ADDENDUM NO. 05

RANKIN TRAILS AMPHITHEATER AND BASEBALL PARK

Rankin County, Mississippi

WBA Proj. # 2215/2315

ADD5-E5

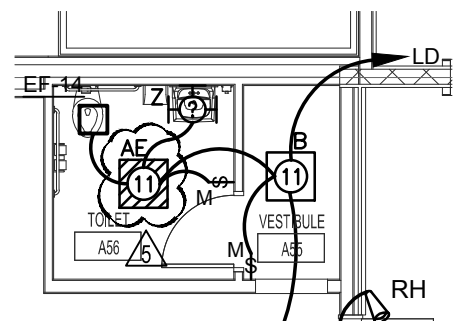
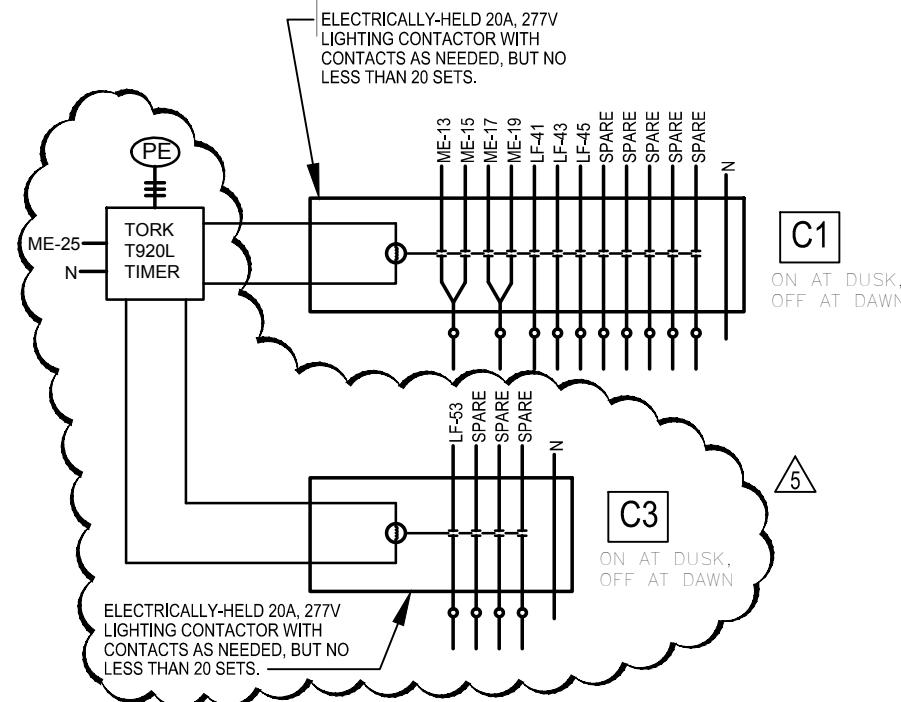
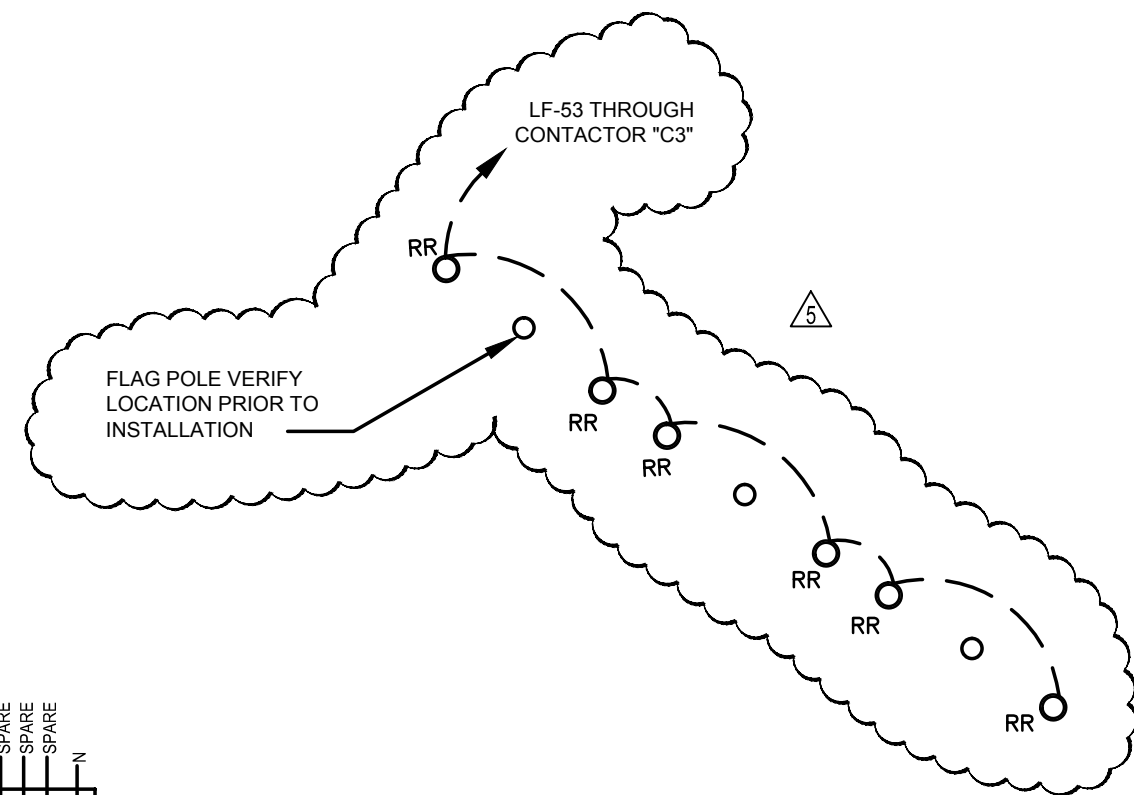
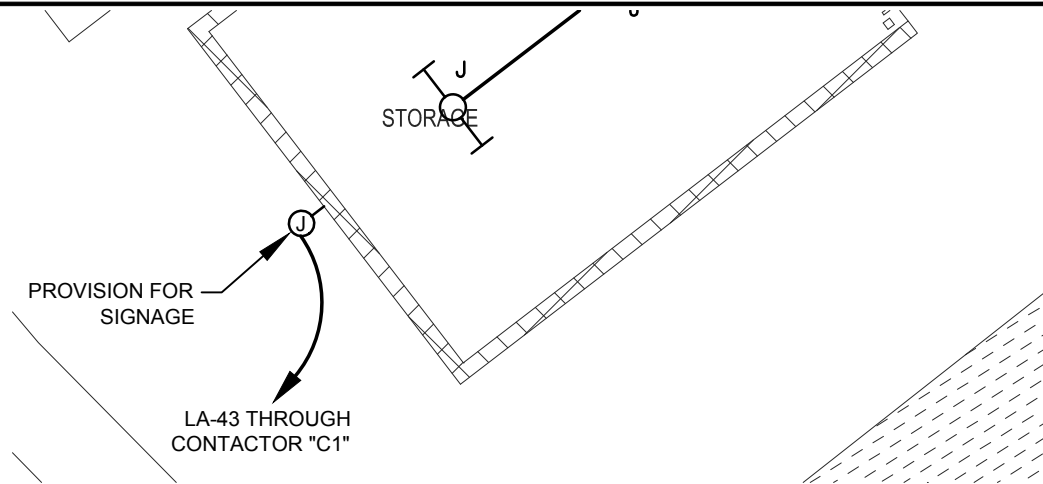
- ITEM NO. 16** **SHEET E1.10**
REVISE per enclosed sheet ADD5-E4.
- ITEM NO. 17** **SHEET E1.11, E1.12**
REVISE per enclosed sheet ADD5-E5.
- ITEM NO. 18** **SHEET E1.20**
REVISE per enclosed sheet ADD5-E6.

SHEET:
ADD5-E7

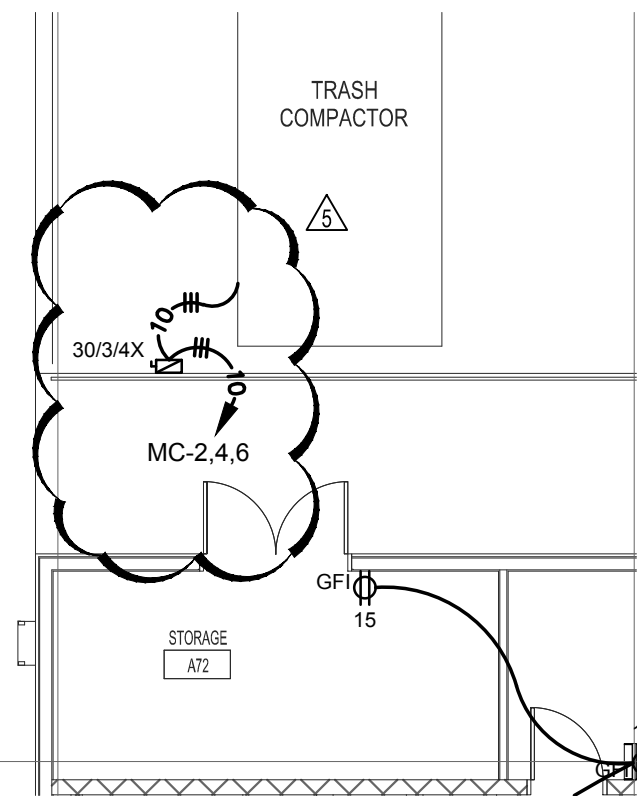
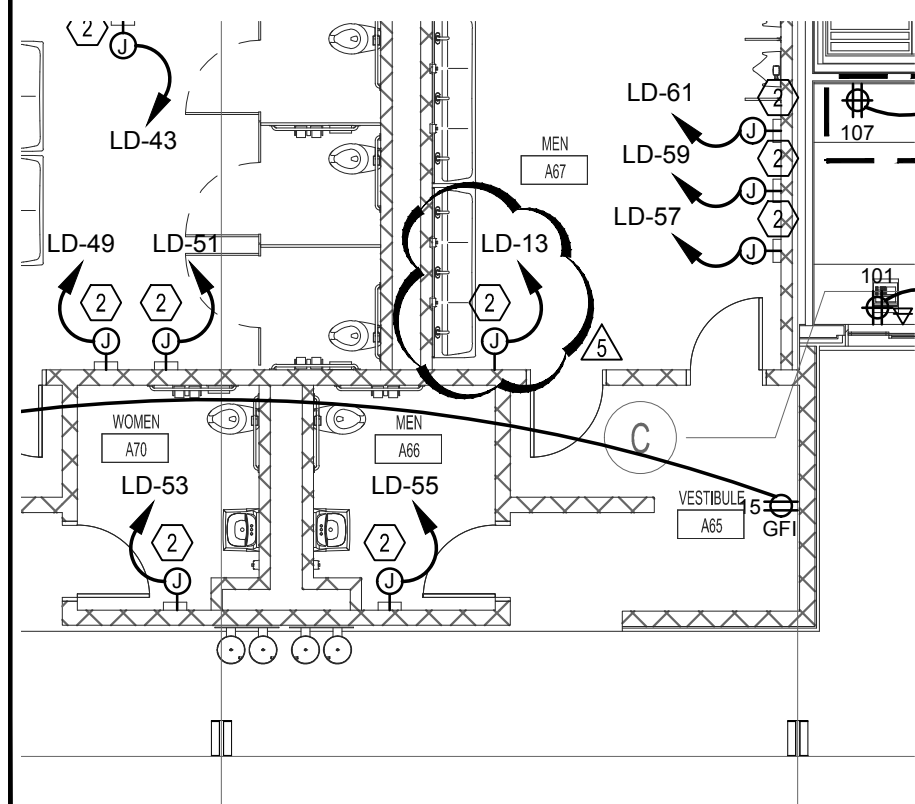
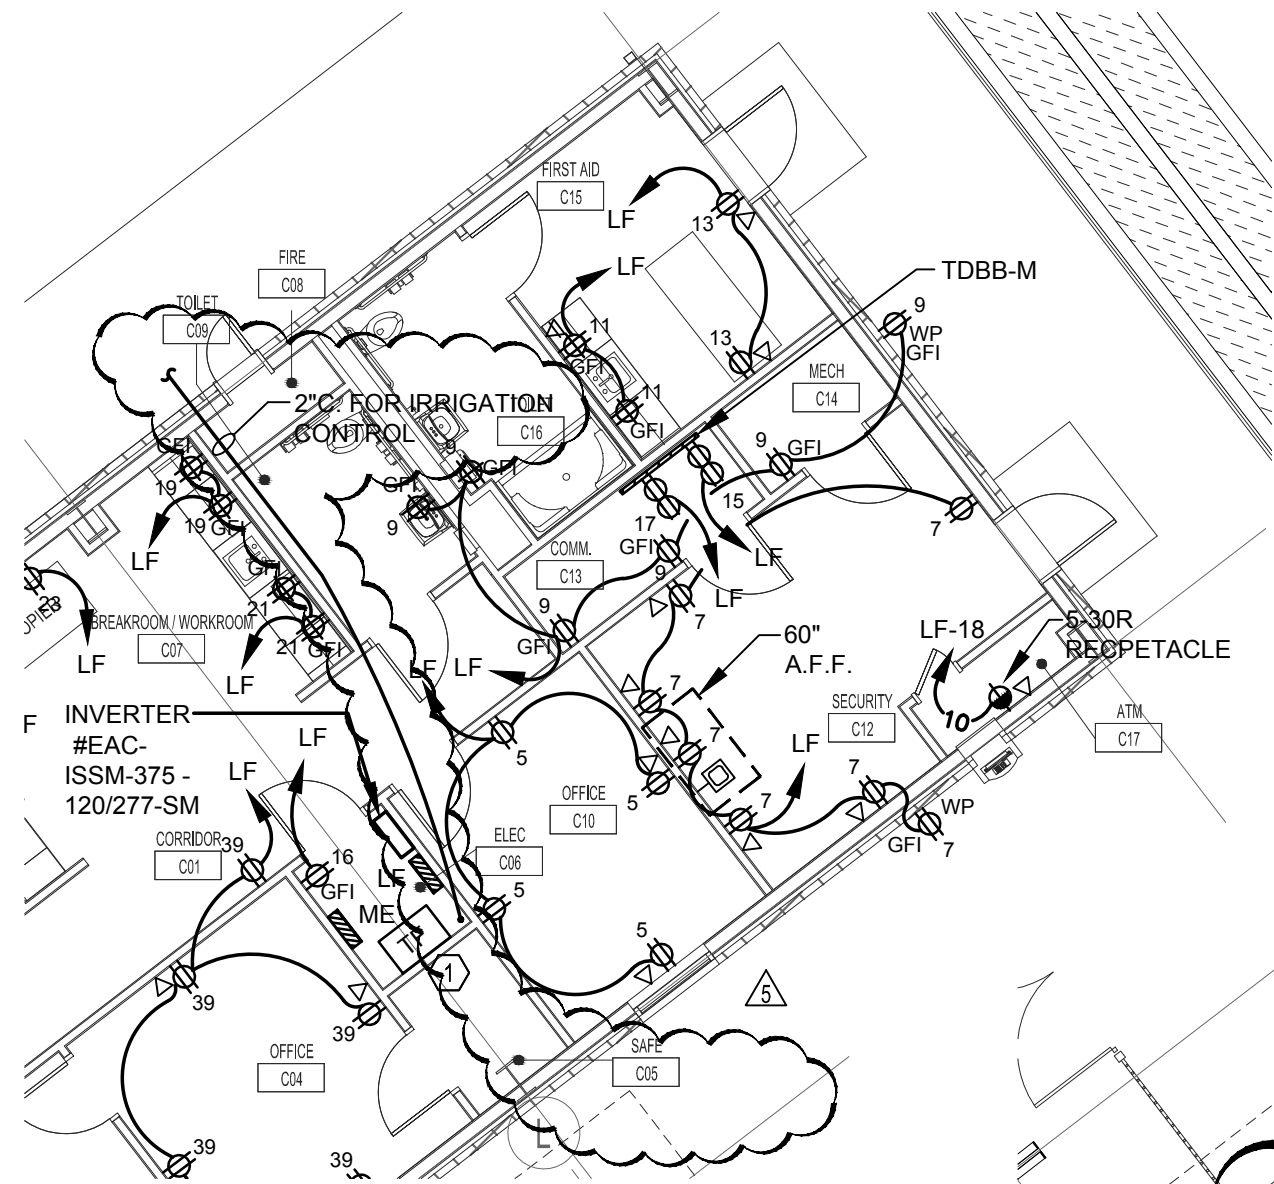
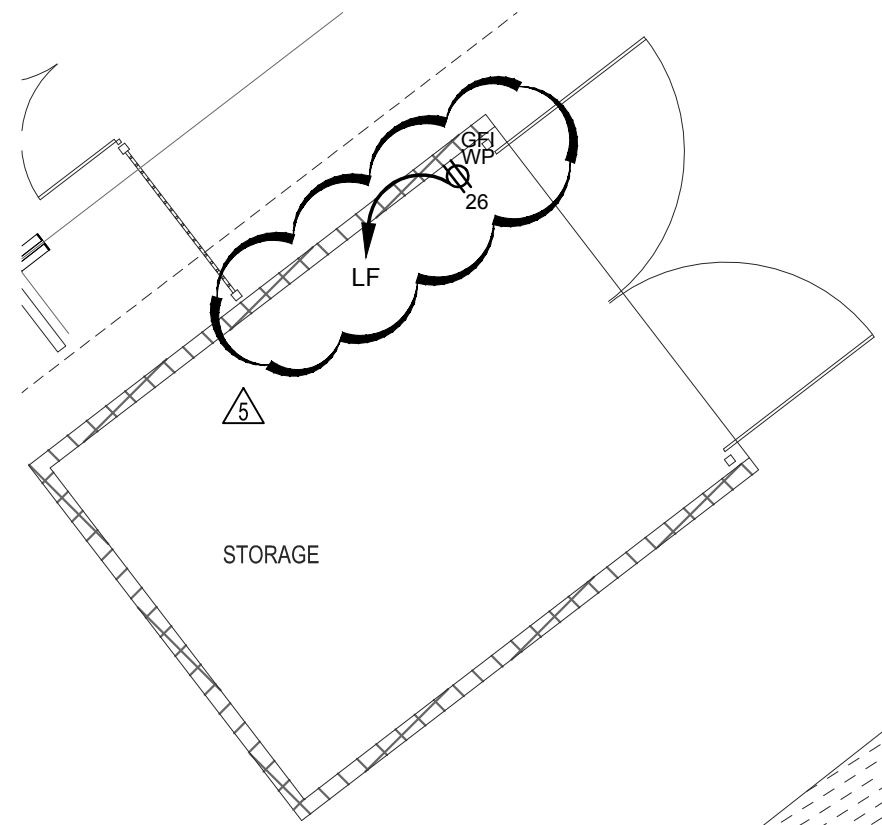
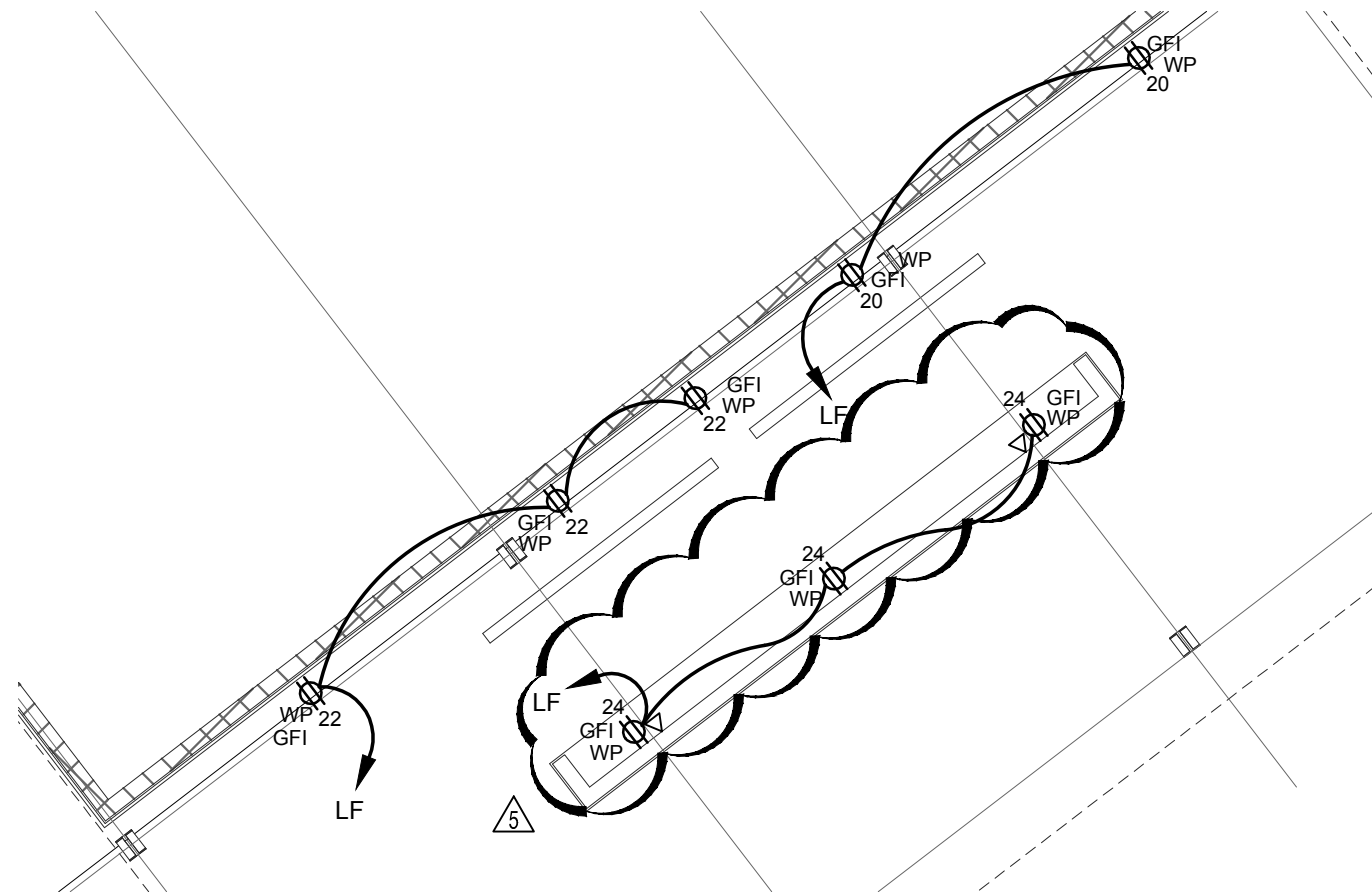
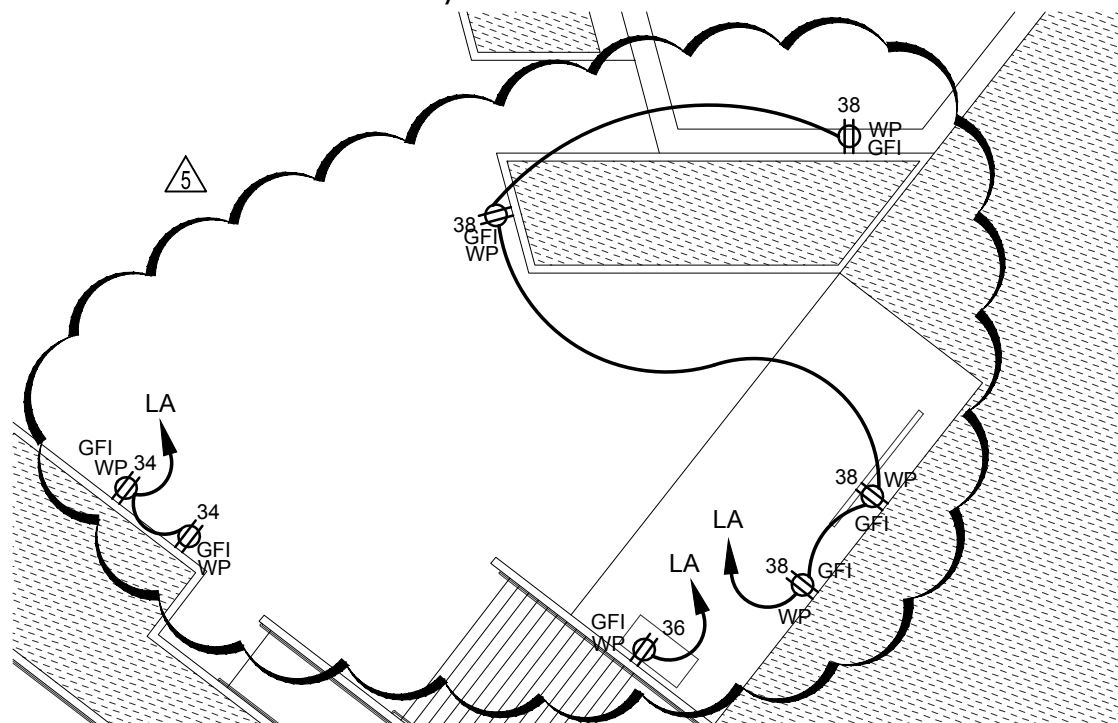
- ITEM NO. 19** **SHEET E1.21, E1.22**
REVISE per enclosed sheet ADD5-E7.

ITEM NO. 20 **SHEET E1.22, E1.23**
REVISE per enclosed sheet ADD5-E8.

ADD5-E9

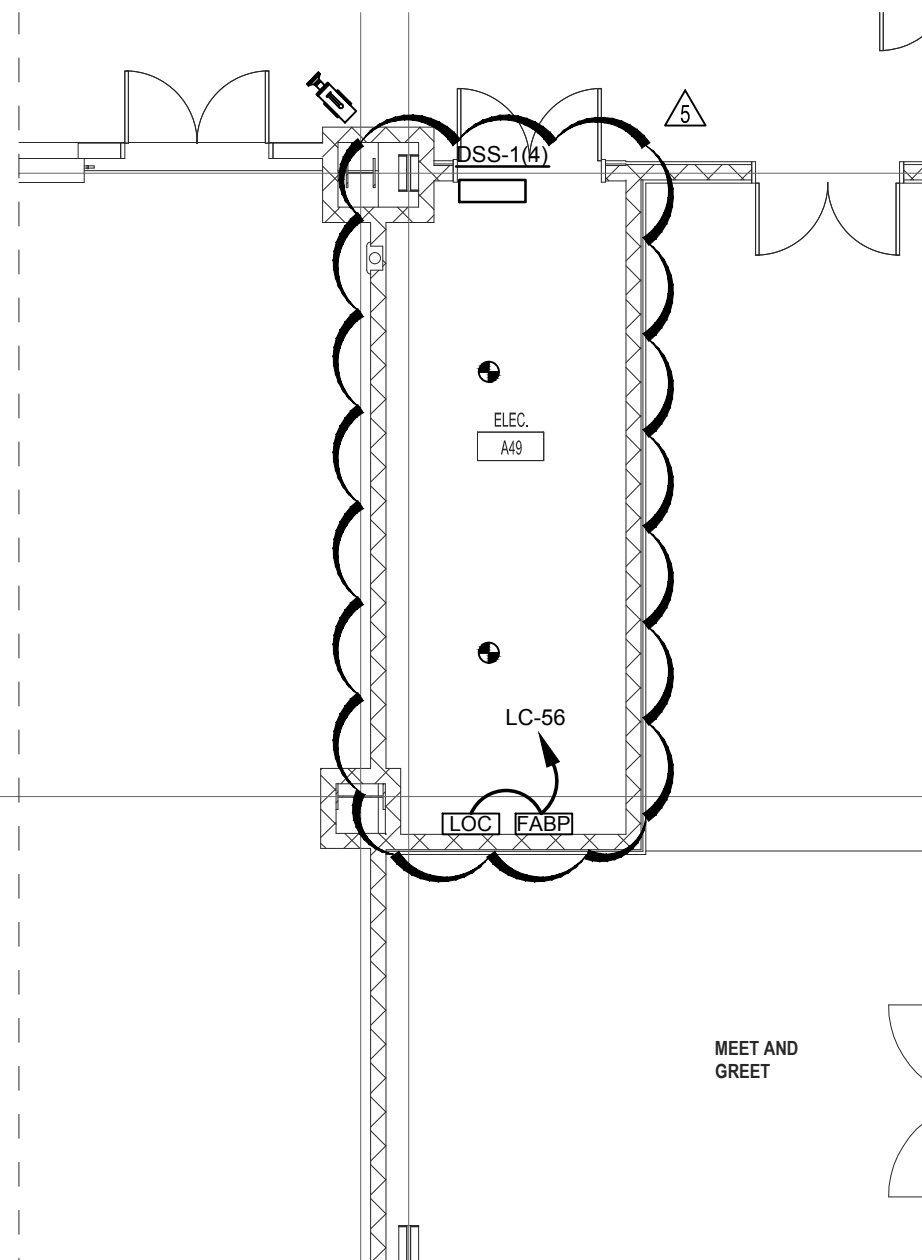
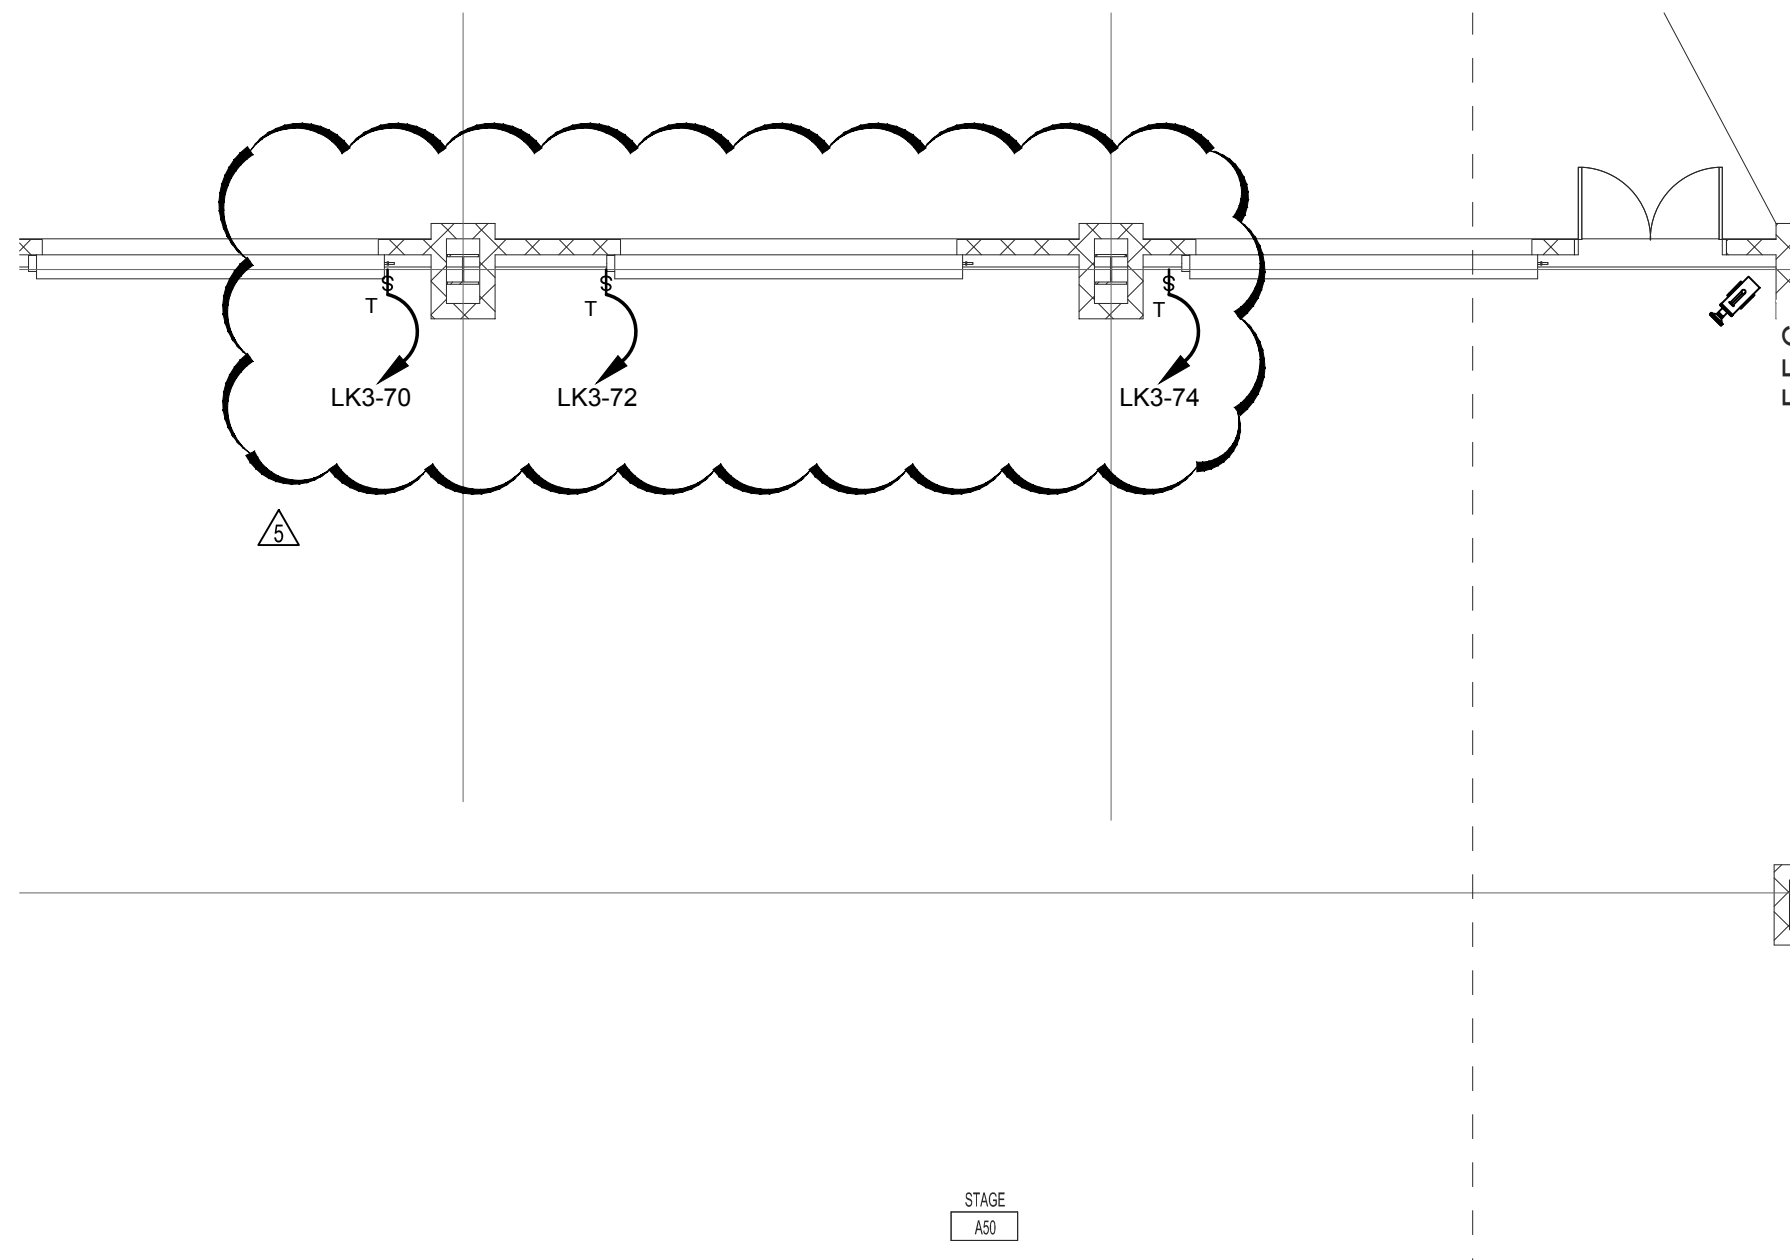
ITEM NO. 21 **SHEET E1.30, E 1.31**
REVISE per enclosed sheet ADD5-E9.
